Final Steyning Parish Council {SPC} comments concerning Reserved Matters Planning Application:-

DC/25/1138 – Land north of Glebe Farm & Kings Barn Lane

Indicative technical illustration of Number 43 boundary buffer.

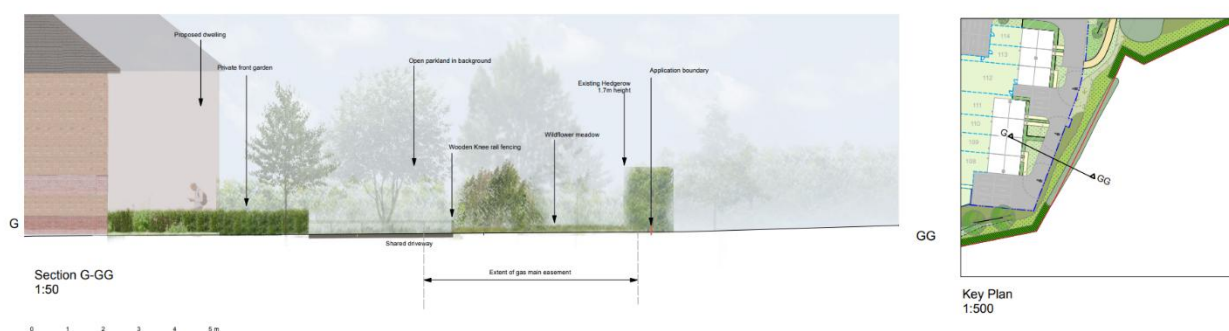
SPC appreciate there has been compromise, with Vistry now including wider gaps between boundary walls, including additional planting, and that trees would be part of the solution – and to ensure that these measures are adhered to. However, also to be aware of the following which has been discussed at many community engagement meetings since 13th March 25 – SPC request that Vistry ensure there is a planning condition attached to the reserved matters approval requiring commitment to consult with KBL residents (within a timescale agreed with the ward member) regarding details of the boundary treatments and advanced planning in this area (to include but not limited to 5m buffer, 1.8m fencing inside any of the existing substantial hedges, security, woodland structural planting and the maintenance thereof). Refer also to Condition 17 of the Planning Committee Report (26th September 2024) which requires “structural planting along buffer zones to be retained/enhanced” and Policy 30 and 33 of the HDPE.

Post meeting note: the illustration should form part of these minutes. One being at no 43 Kings Barn Lane pinch point.

We agreed that the security gates at either end would not be required because it didn't need two lines of fencing due to the dense planting and that to illustrate this more accurately, at least 3 cross sections showing boundary design and planting would be provided.

VISTRY: We have pressed the utilities statutory undertakers to respond to technical constraints for planting request and provide clarification on what is permissible for planting schedules on the easements and boundary. Once these have been provided our landscape and technical team will issue further detailed plans and illustrations of these cross sections, which will be fully addressed at condition discharge stage.

Members appreciated the work done by Vistry to amend the plans and also in providing cross sectional representations of the design which includes measurements and planting/ structural installations as detailed in emails to Councillor Finnegan subsequent to the meeting dated 14th October and now attached to this document within Appendix 1. This has eased the concerns from residents living adjacent this boundary and the final design was appreciated by members **without objection.**
